Informal document No. GRSP-48-12  
(48th GRSP, 7 - 10 December 2010, agenda item 3)

Amendments to the proposal to develop Phase II of gtr No. 7  
and to establish an informal group for its development

Gtr No. 7 (Head restraints)

**Whiplash Injuries in Japan (GTR7-02-16e, pg 6)**

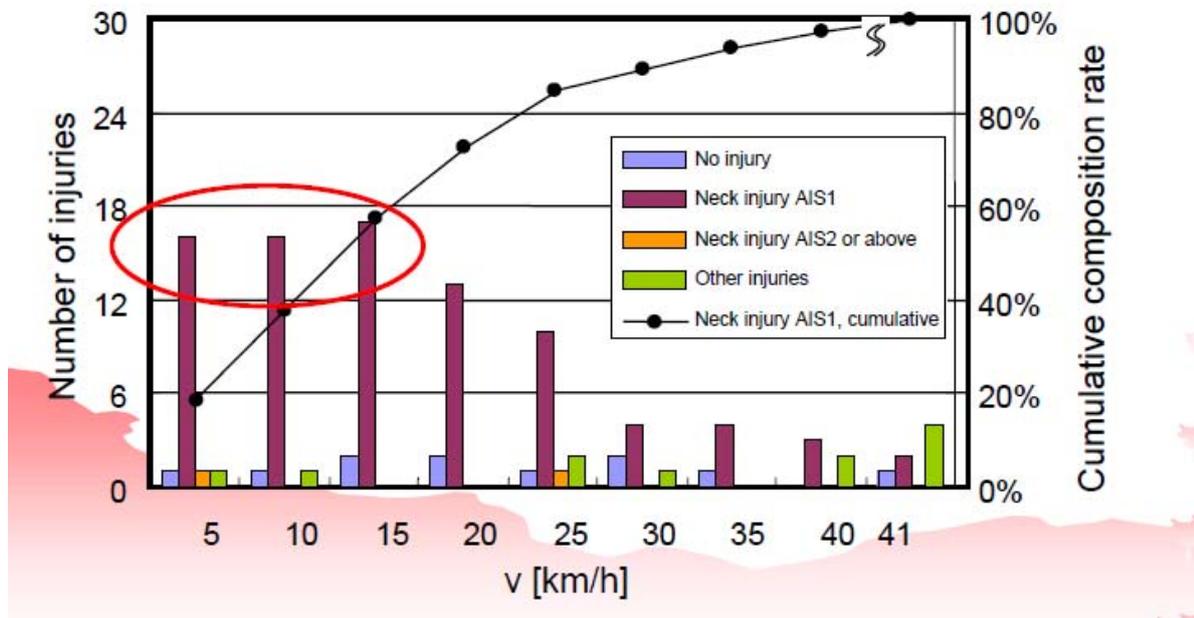
A deeper review of United States of America's (USA) initial data shows that while there are a significant number of AIS 2 and AIS 3 injuries occurring in rear impact crashes greater than 18 km/h, most of the neck injuries, which can be evaluated by rear impact dummies, are AIS 1 and AIS 2. For AIS 1 injuries, there are approximately an equal number of occurrences below 18 km/h as there are above 18 km/h. Research from Japan shows similar trends, with a significant number of injuries occurring in the range of 15 – 25 km/h.

An evaluation of research titled “Recommendations for a Low-speed Rear Impact Sled Test Pulse” conducted by the EEVC concluded that most long term whiplash injuries are sustained at speeds between 16 km/h and 25 km/h.
